**2021 CMOM Package 7
Solicitation Number: CO-00685
Job No.: 22-4516**

**ADDENDUM 2
October 24, 2023**

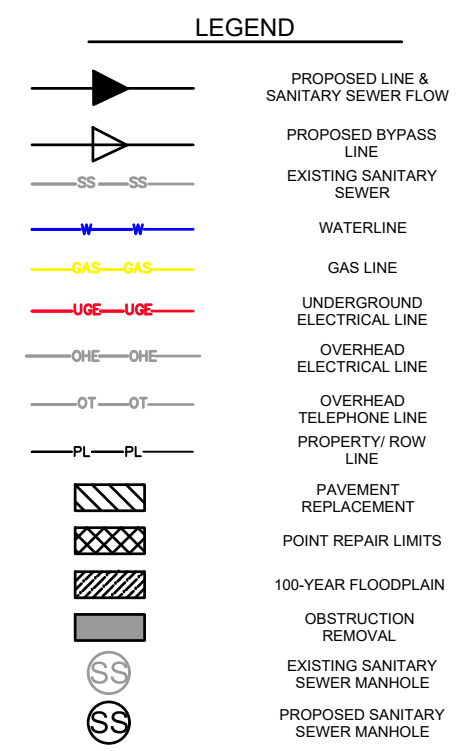
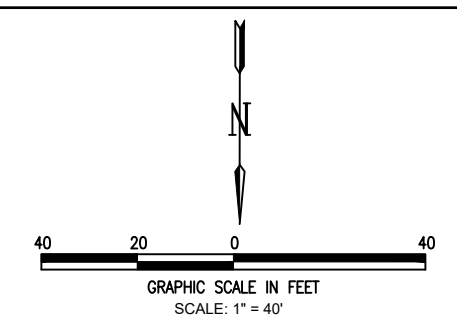
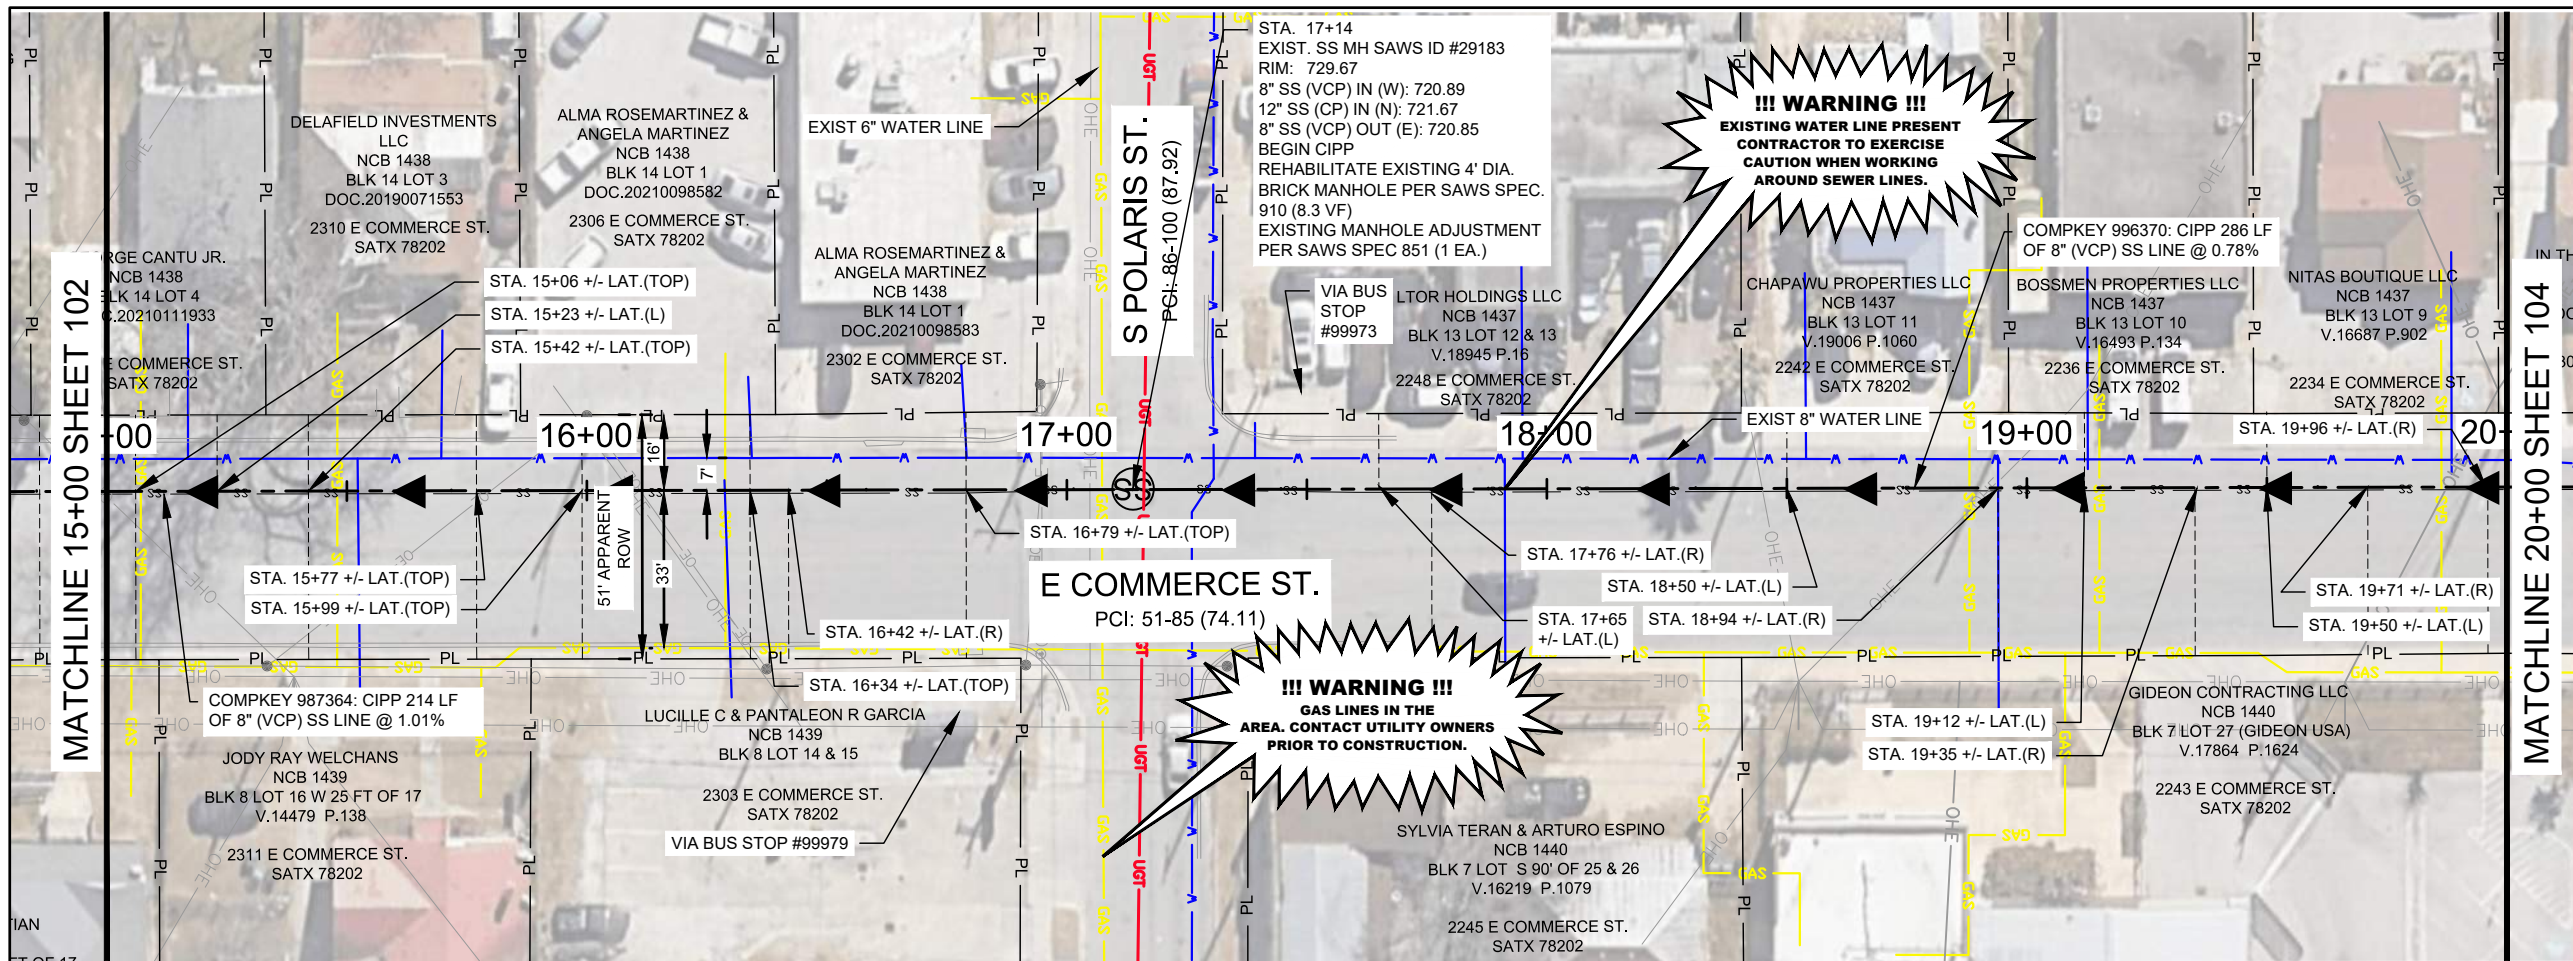
- i. Sheet 102 SITE 28 CMPKY 987364 STA 10+00 - 15+00 CIPP RHB & PNT RPR
 - The note "SAWS IS IN THE PROCESS OF OBTAINING A PHASE II ESA REPORT FOR THIS SITE. REFER TO CONTRACT DOCUMENTS SC10" was removed.

- The note "CONTRACTOR TO REFER TO PHASE II ESA REPORT PROVIDED BY SAWS. SOILS GENERATED FROM BELOW A DEPTH OF 10 FEET DEEP AND SOILS EXCAVATED DOWN TO 5 FEET BELOW REMOVED PAVEMENTS ARE TO BE REUSED BENEFICIALLY ON SITE OR TREATED AND APPROPRIATELY DISPOSED OF AS NON-HAZARDOUS WASTE (NSPI)" was added.

- CONTRACTOR TO COORDINATE AND NOTIFY VIA REGARDING BUS ROUTES. REFER TO VIA NOTES ON SHEET 4
- CONTRACTOR TO REFER TO PHASE II ESA REPORT PROVIDED BY SAWS. SOILS GENERATED FROM BELOW A DEPTH OF 10 FEET DEEP AND SOILS EXCAVATED DOWN TO 5 FEET BELOW REMOVED PAVEMENTS ARE TO BE REUSED BENEFICIALLY ON SITE OR TREATED AND APPROPRIATELY DISPOSED OF AS NON-HAZARDOUS WASTE (NSPI).

2021 CMOM PKG 7
SITE 28 CMPKY 987364, 996370 STA 15+00 - 20+00 CIPP RHB

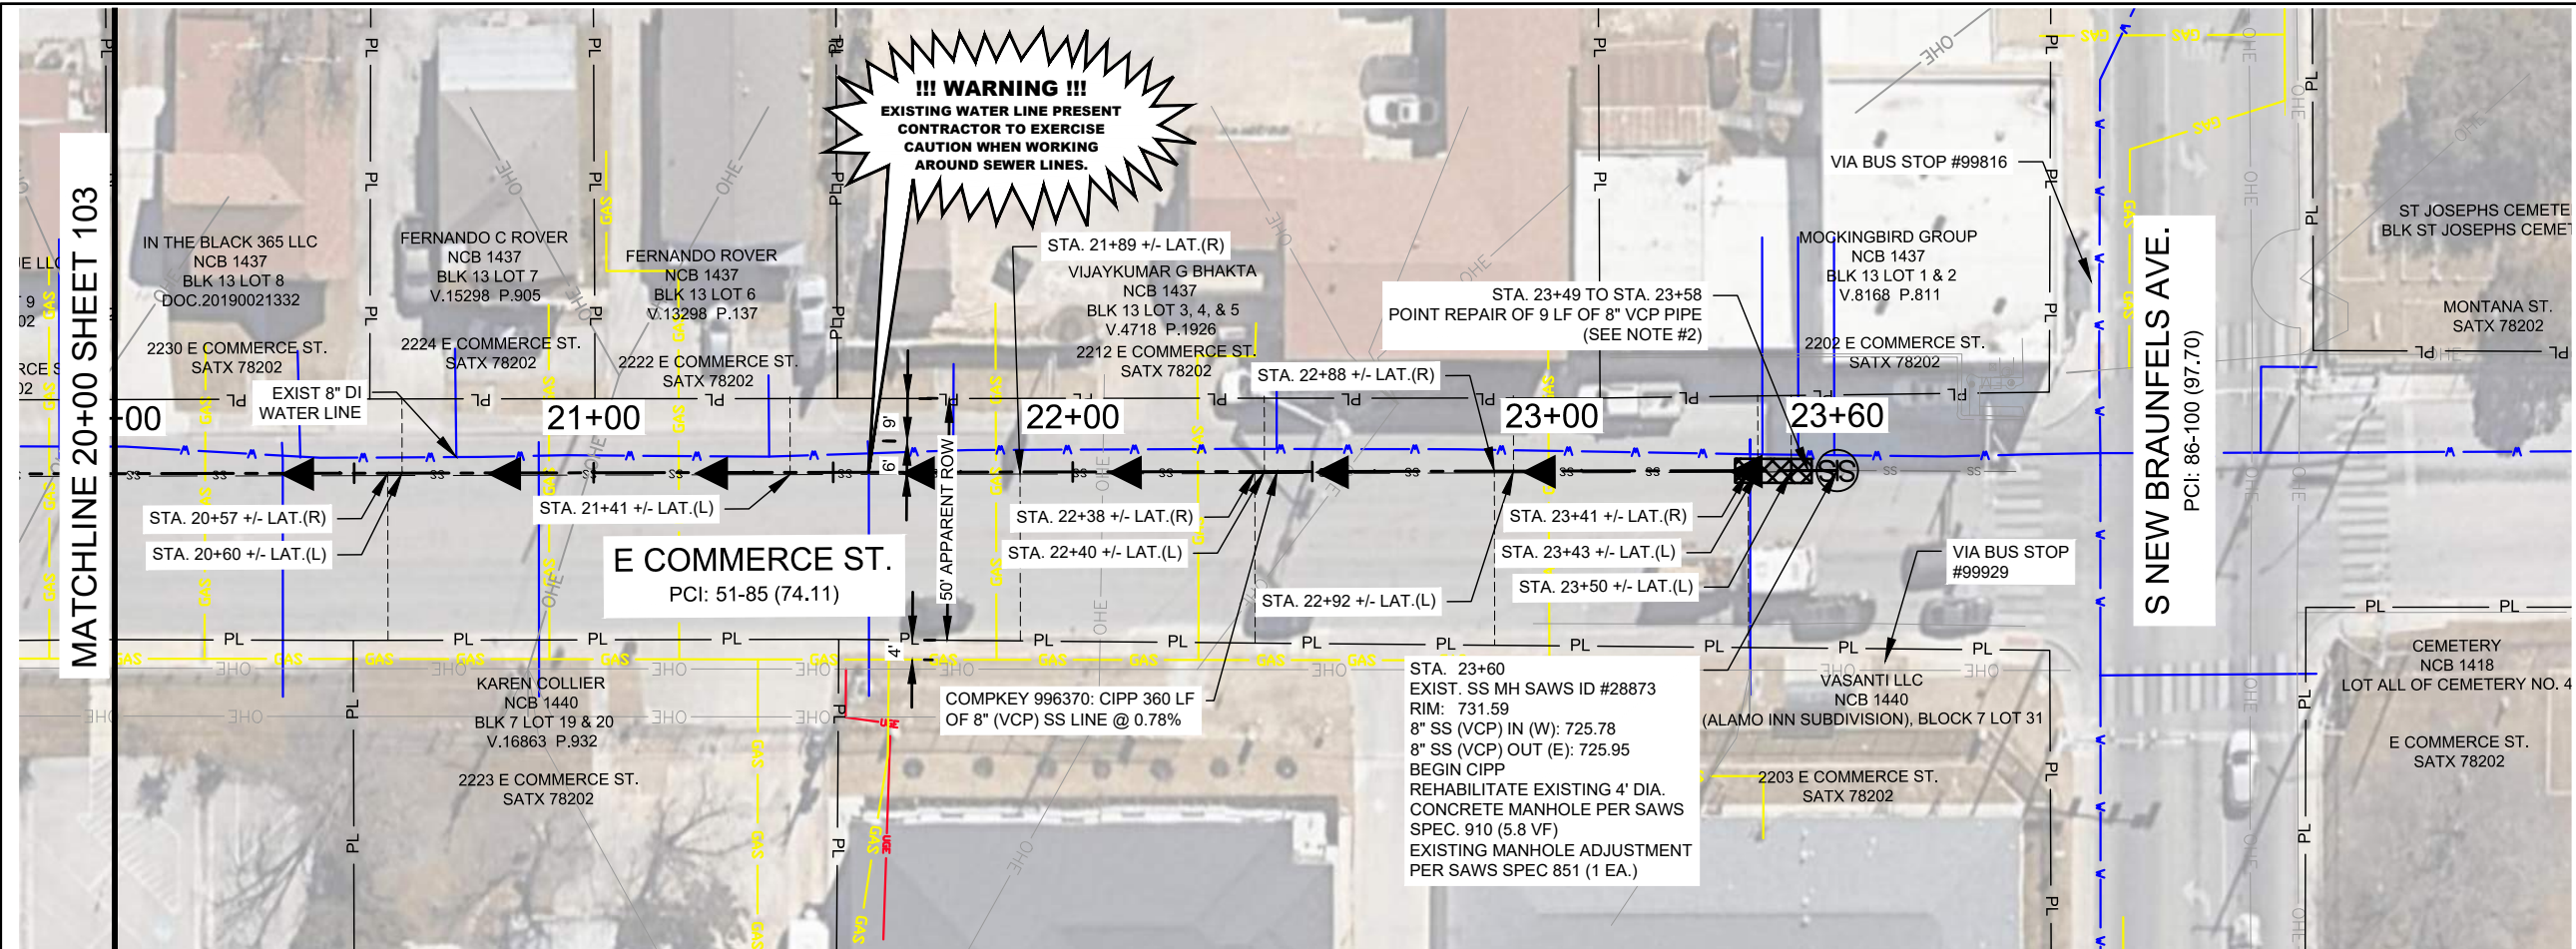
- j. Sheet 103 SITE 28 CMPKY 987364, 996370 STA 15+00 - 20+00 CIPP RHB
 - The note "SAWS IS IN THE PROCESS OF OBTAINING A PHASE II ESA REPORT FOR THIS SITE. REFER TO CONTRACT DOCUMENTS SC10" was removed.

- The note "CONTRACTOR TO REFER TO PHASE II ESA REPORT PROVIDED BY SAWS. SOILS GENERATED FROM BELOW A DEPTH OF 10 FEET DEEP AND SOILS EXCAVATED DOWN TO 5 FEET BELOW REMOVED PAVEMENTS ARE TO BE REUSED BENEFICIALLY ON SITE OR TREATED AND APPROPRIATELY DISPOSED OF AS NON-HAZARDOUS WASTE (NSPI)" was added.

- CONTRACTOR TO COORDINATE AND NOTIFY VIA REGARDING BUS ROUTES. REFER TO VIA NOTES ON SHEET 4.
- CONTRACTOR TO VERIFY AT&T INFRASTRUCTURE PRIOR TO CONSTRUCTION.
- CONTRACTOR TO REFER TO PHASE II ESA REPORT PROVIDED BY SAWS. SOILS GENERATED FROM BELOW A DEPTH OF 10 FEET DEEP AND SOILS EXCAVATED DOWN TO 5 FEET BELOW REMOVED PAVEMENTS ARE TO BE REUSED BENEFICIALLY ON SITE OR TREATED AND APPROPRIATELY DISPOSED OF AS NON-HAZARDOUS WASTE (NSPI).

2021 CMOM PKG 7
SITE 28 CMPKY
987364.996370 STA 20+00
- 23+60 CIPP RHB & PNT RPR

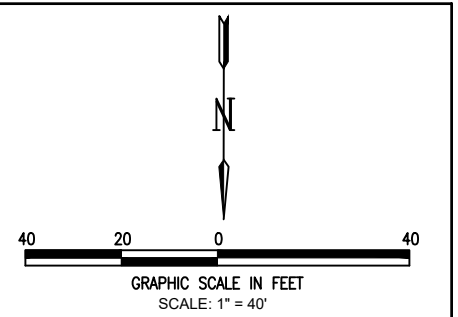
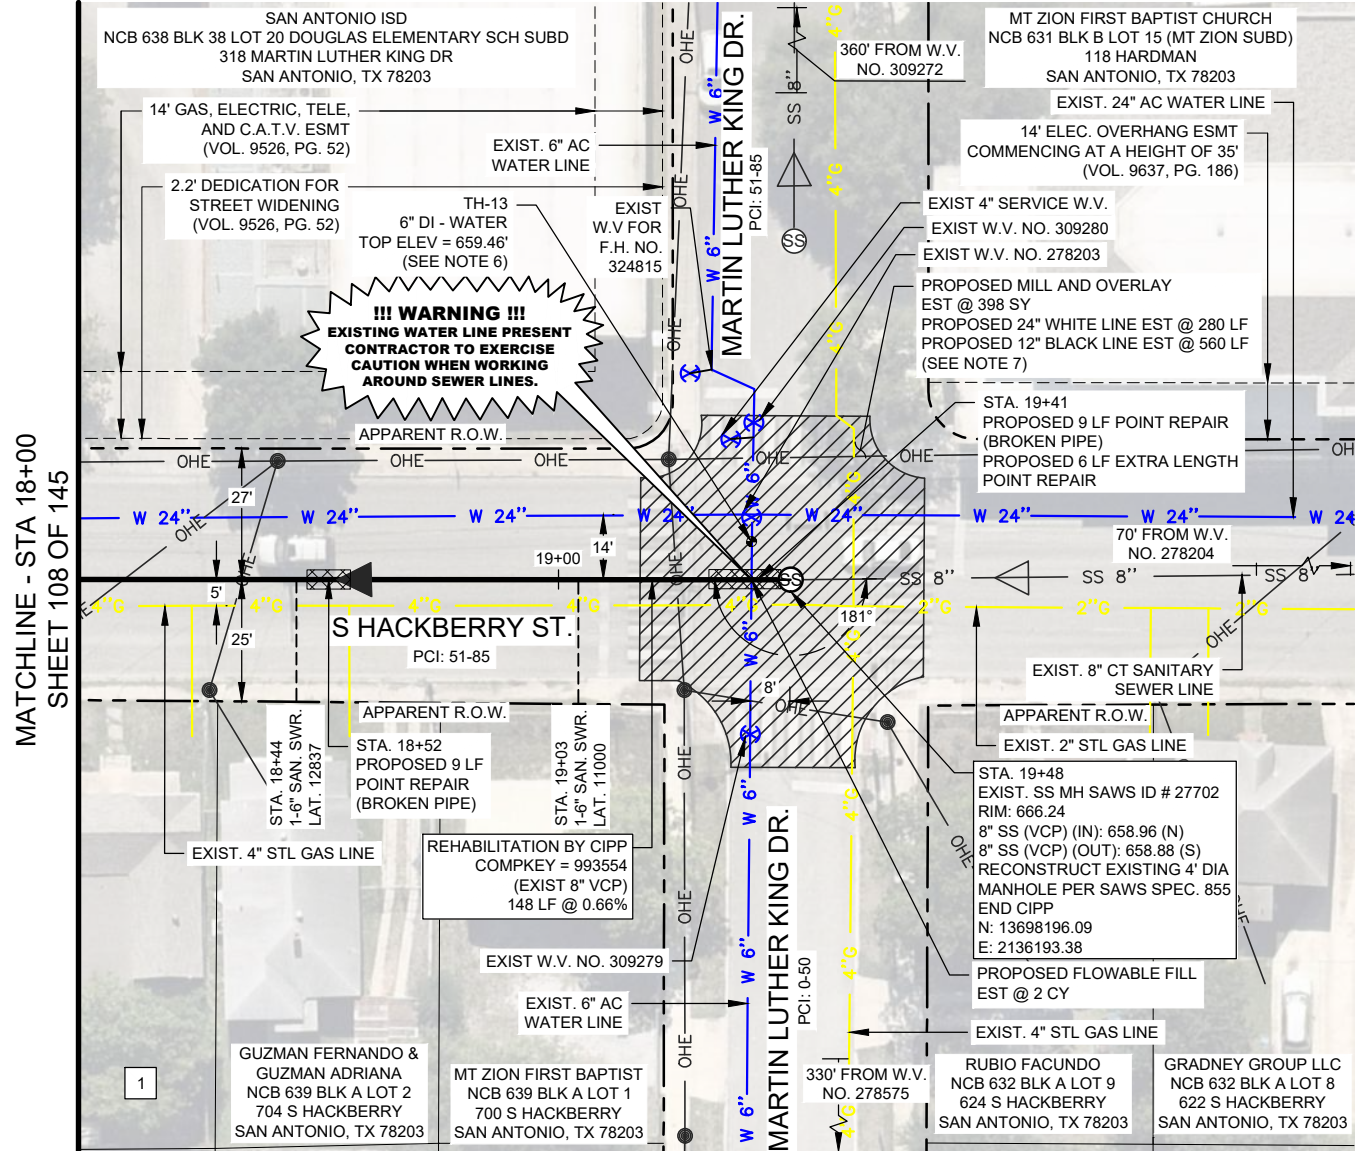
- k. Sheet 104 SITE 28 CMPKY 987364, 996370 STA 20+00 - 23+60 CIPP RHB & PNT RPR
 - The note "SAWS IS IN THE PROCESS OF OBTAINING A PHASE II ESA REPORT FOR THIS SITE. REFER TO CONTRACT DOCUMENTS SC10" was removed.

- The note "CONTRACTOR TO REFER TO PHASE II ESA REPORT PROVIDED BY SAWS. SOILS GENERATED FROM BELOW A DEPTH OF 10 FEET DEEP AND SOILS EXCAVATED DOWN TO 5 FEET BELOW REMOVED PAVEMENTS ARE TO BE REUSED BENEFICIALLY ON SITE OR TREATED AND APPROPRIATELY DISPOSED OF AS NON-HAZARDOUS WASTE (NSPI)" was added.

- CONTRACTOR TO COORDINATE AND NOTIFY VIA REGARDING BUS ROUTES. REFER TO VIA NOTES ON SHEET 4.
- CONTRACTOR SHALL PERFORM SEWER POINT REPAIR AND RELOCATE PENETRATING WATER LATERAL AT STA. 23+52, 2 FEET ABOVE THE SEWER MAIN AND SHALL ENCASE THE SEWER MAIN IN CEMENT STABILIZED SAND PER TCEO REQUIREMENTS.
- CONTRACTOR TO REFER TO PHASE II ESA REPORT PROVIDED BY SAWS. SOILS GENERATED FROM BELOW A DEPTH OF 10 FEET DEEP AND SOILS EXCAVATED DOWN TO 5 FEET BELOW REMOVED PAVEMENTS ARE TO BE REUSED BENEFICIALLY ON SITE OR TREATED AND APPROPRIATELY DISPOSED OF AS NON-HAZARDOUS WASTE (NSPI).

2021 CMOM PKG 7
 SITE 29
 COMPKEY 993554
 STA. 18+00 - 19+48
 CIPP REHAB

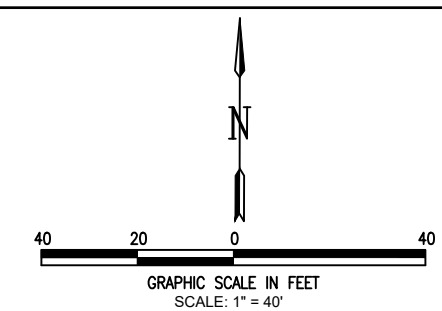
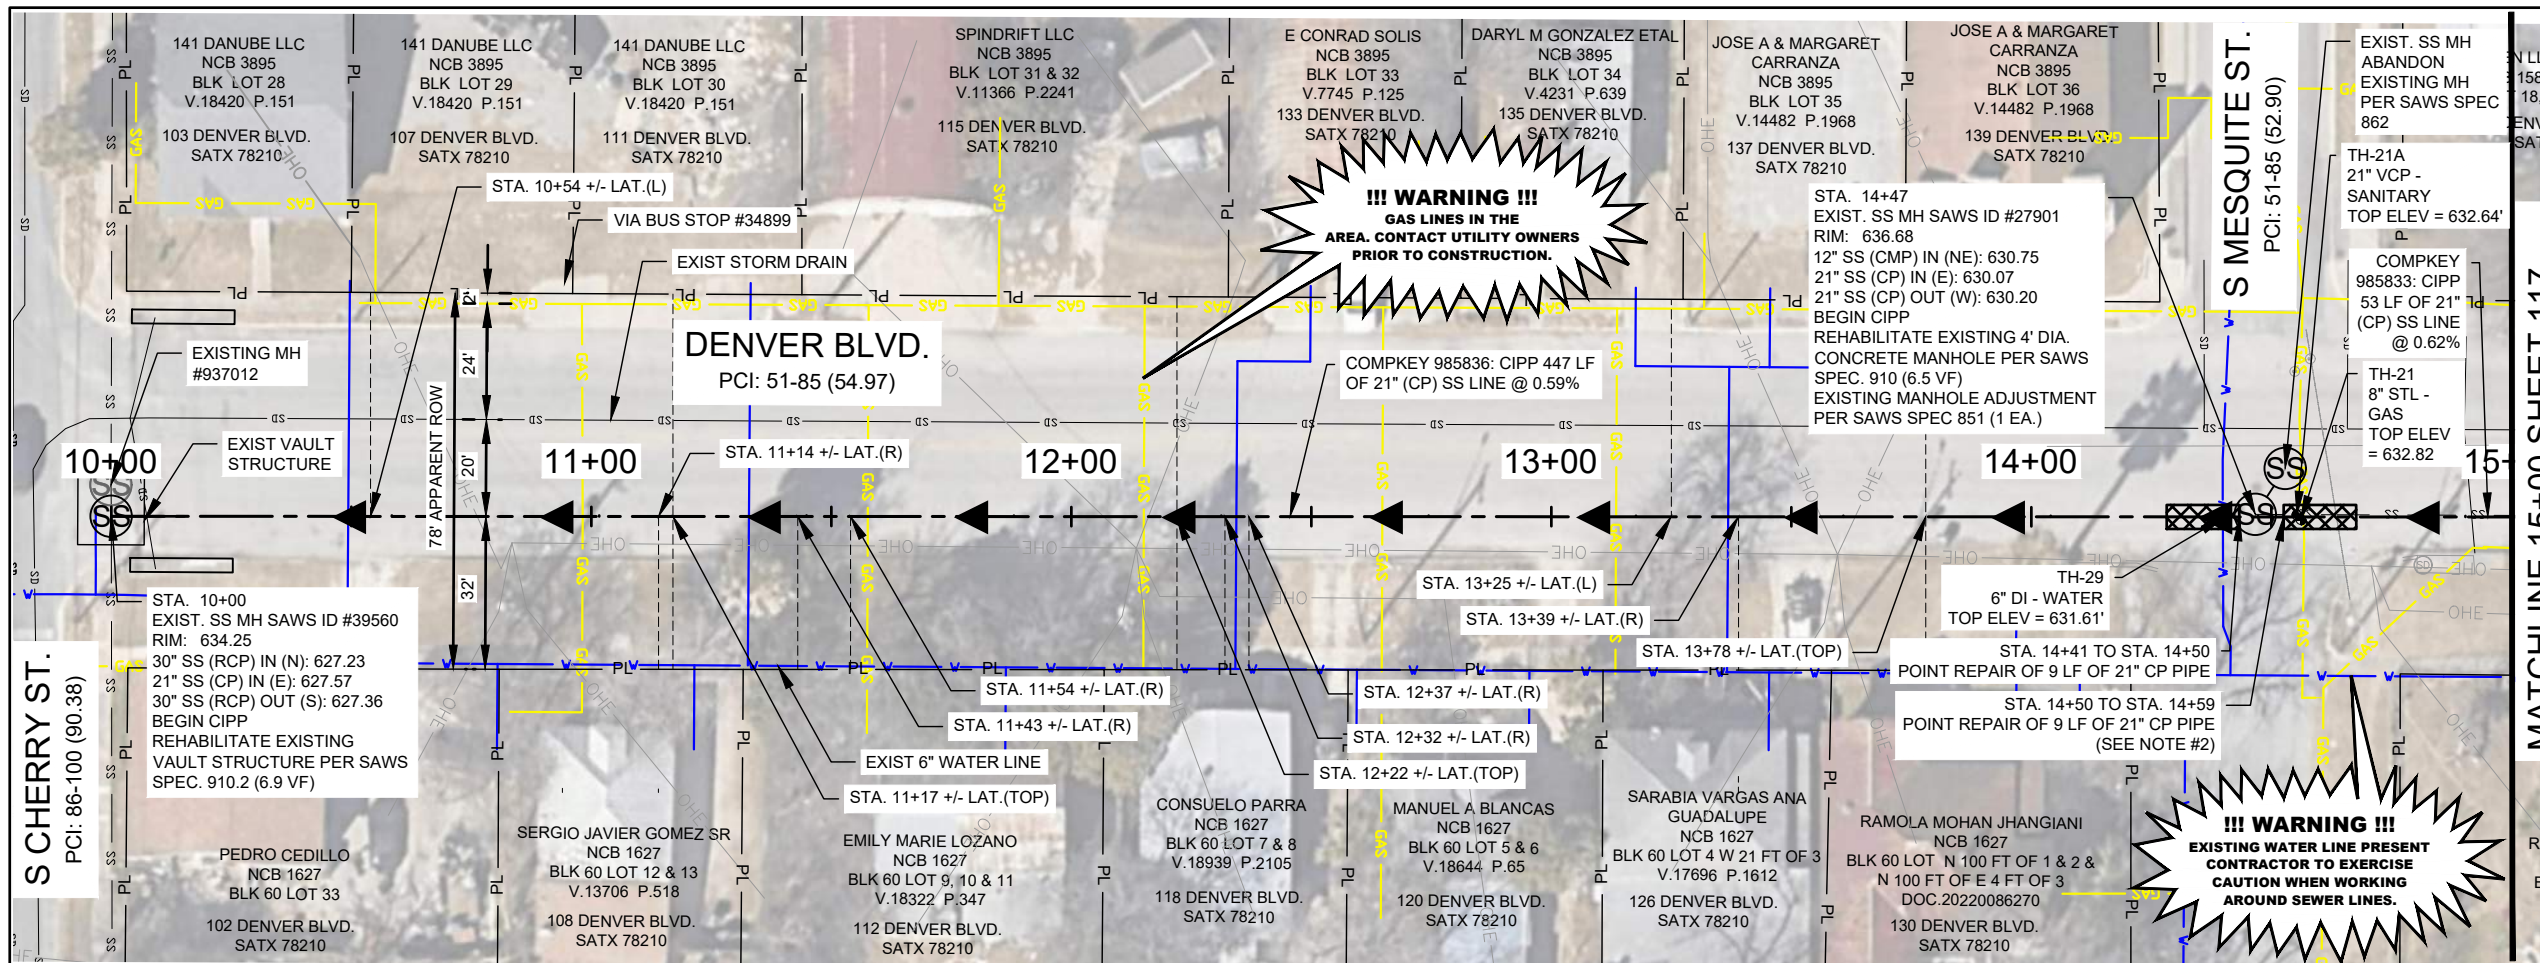
- n. Sheet 109 SITE 29 COMPKEY 993554 STA. 18+00 - 19+48 CIPP REHAB
 - The note "CONTRACTOR TO REFER TO PHASE II ESA REPORT PROVIDED BY SAWS. SOILS WITH INTERMIXED ASPHALT PIECES ARE TO BE REUSED BENEFICIALLY ON SITE OR TREATED AND APPROPRIATELY DISPOSED OF AS NON-HAZARDOUS WASTE (NSPI)" was added.
